Access Compliance Report

Public Rights-of-Way

(Curb Ramps)

Intersection ID: 6011	Main Street: UNIVERSITY_CITY_BV	Cross Street: MARK_TWAIN_RD	Location: SE
ADA ID: 2F76B7CB8539	Ramp Type: Perp	Initial Pass/Fail: Fail	Overall Compliance: No
			Severity Score: 13.75

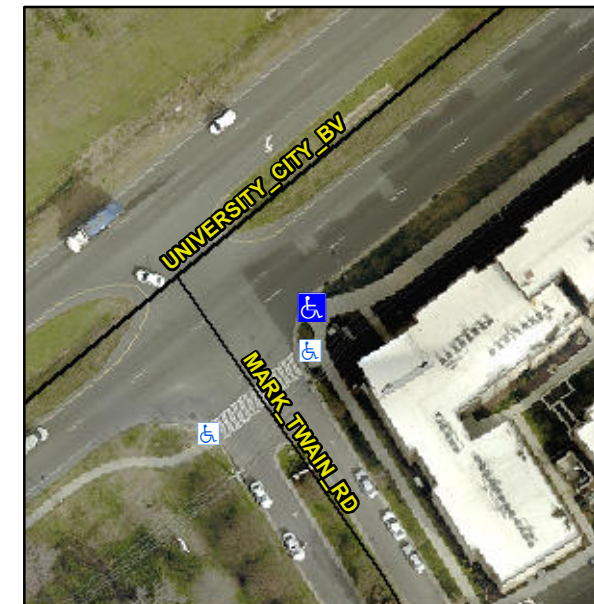
R304.2.2, R304.5.3

Compliance	Description	Data	Compliance	Description	Data
N/A	Ramp Length (in)	90.0	No	Ramp Slope (%)	8.5
Yes	Ramp Width (in)	123.0	No	Ramp XSlope (%)	3.9
N/A	Flare Type LT	N/A	N/A	Flare Type RT	N/A
N/A	Flare Slope LT (%)	N/A	N/A	Flare Slope RT (%)	N/A
N/A	Flare Traversable LT?	N/A	N/A	Flare Traversable RT?	N/A
N/A	Landing Length (in)	N/A	N/A	DWS Provided?	N/A
N/A	Landing Width (in)	N/A	N/A	DWS Contrast?	N/A
N/A	Landing Slope (%)	N/A	N/A	DWS Length (in)	N/A
N/A	Landing X Slope (%)	N/A	N/A	DWS Full Width?	N/A
N/A	Landing Curb? (Y/N)	N/A	N/A	DWS Offset (in)	N/A
N/A	Shared Landing?	N/A			
N/A	Gutter Ponding?	N/A	N/A	Gutter Slope (%)	N/A
N/A	Gutter Lip Ht (in)	N/A	N/A	Gutter X Slope (%)	N/A
N/A	Painted X Walk1?	No	N/A	Painted X Walk2?	N/A
	X Walk 1 Direction	To N		X Walk 2 Direction	N/A
N/A	X Walk 1 Width (in)	N/A	N/A	X Walk 2 Width (in)	N/A
	X Walk 1 Slope (%)	1.8		X Walk 2 Slope (%)	N/A
	X Walk 1 X Slope (%)	3.7		X Walk 2 X Slope (%)	N/A

Remove & Replace Entire Ramp.
